SUNDRY NOTICES AND REPORTS ON WELLS

DOLORES AIL FEDERAL #1

30-015-26547

Permanent Abandonment of Federal Wells
Conditions of Approval (LPC Habitat)

Production Downhole Profile

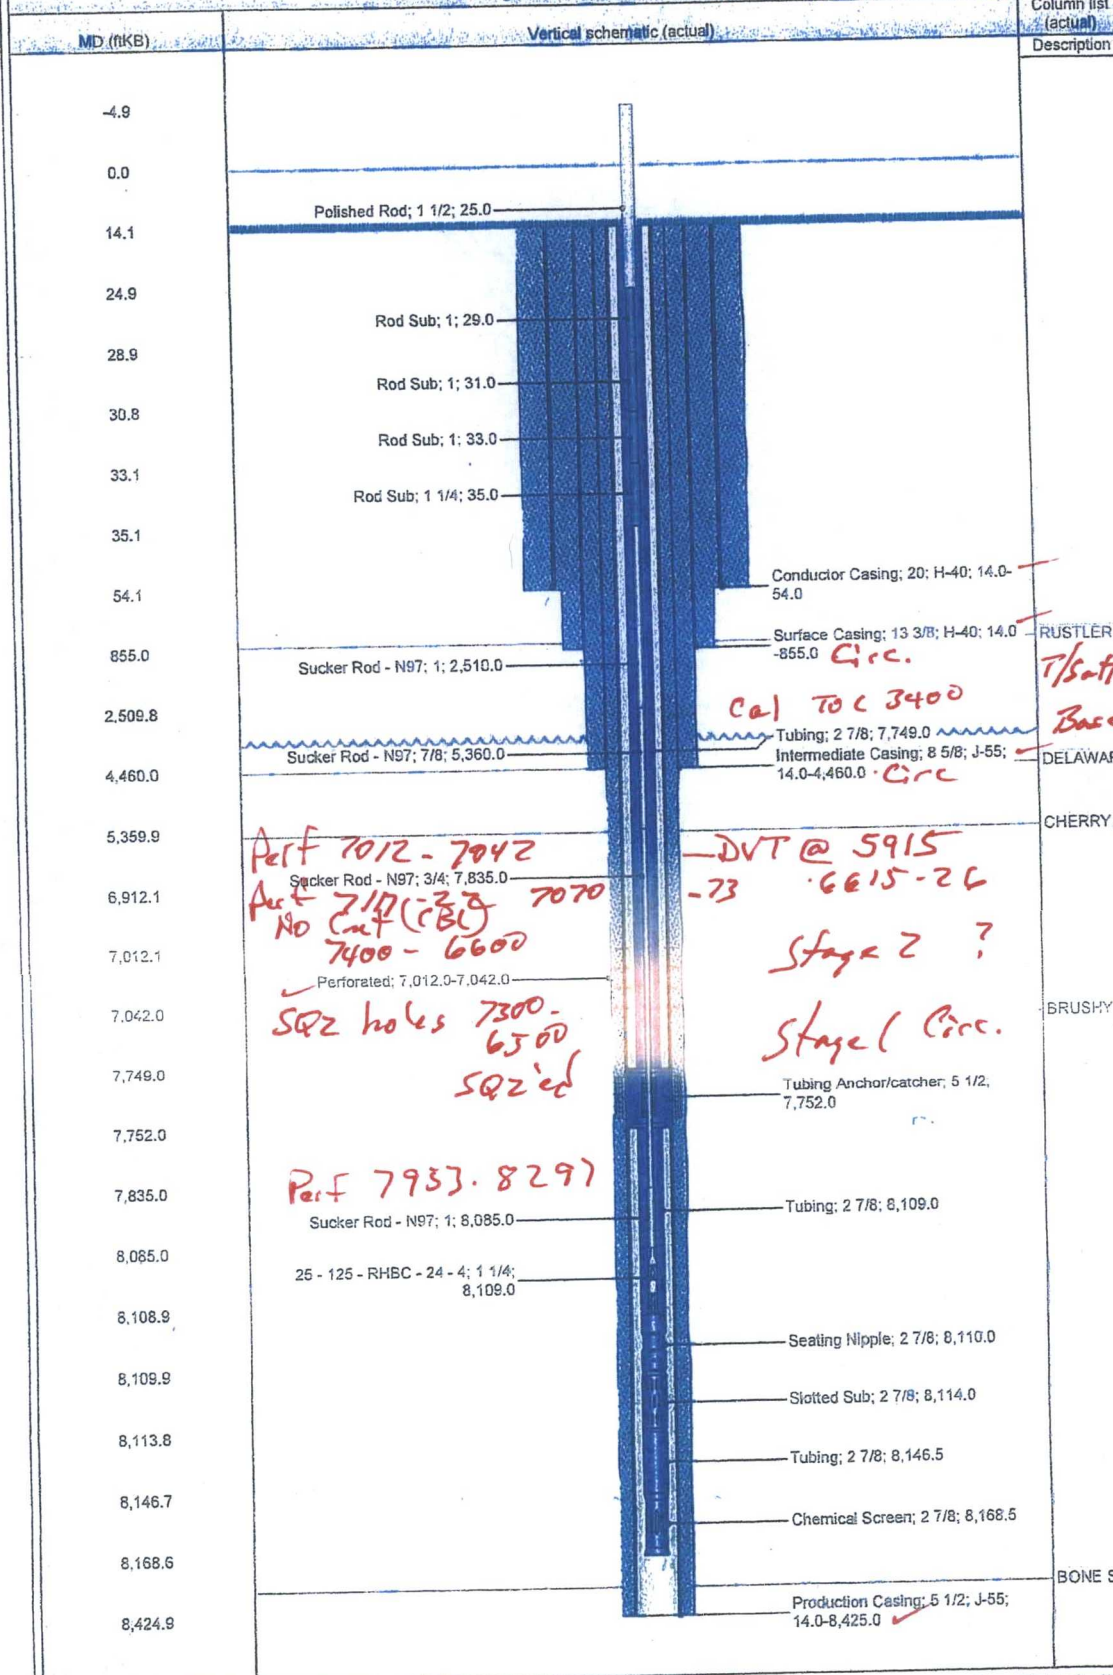
1. Set C.L.B.P. @ 6,926' spot 25sx class H

2. PUH 5,489' spot 25sx class c to 5242'

3. PUH 4494' spot 25sx class c to 4247'

4. PUH 824' spot 25sx class c to 577'

5. PUH 100' spot 15sx to Surface. Verify

Handwritten notes:
 4510 Perf @ 905 sqz cnt to 805
 6565' (Top Perf @ 6615)
 "R-III-A" Solid Along thru Potash
 Perf. attempt to sqz cnt to 4247. wbc Tag. Perf @ Top cnt. attempt to sqz cnt to 1070. wbc Tag. If unable to sqz. contact Jim Amos @ 575-361-2648
